# PCN-20200827 TE0727-01 to TE0727-02 Hardware Revision Change

<b>Company</b>	Trenz Electronic GmbH
<b>PCN Number</b>	PCN-20200827
<b>Title</b>	TE0727-01 to TE0727-02 Hardware Revision Change
<b>Subject</b>	Hardware Revision Change
<b>Issue Date</b>	2020-08-27

## #9 LIB components update

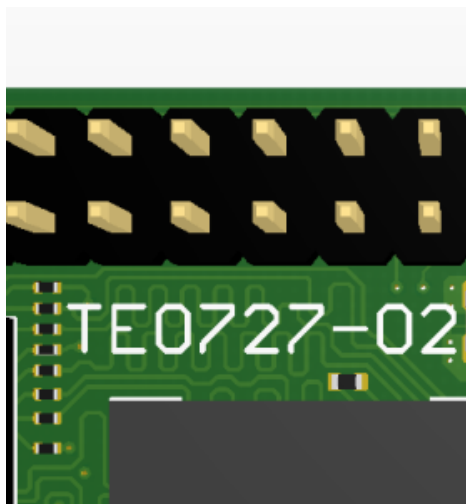
**Type:** Schematic change

**Reason:** Improve production yield.
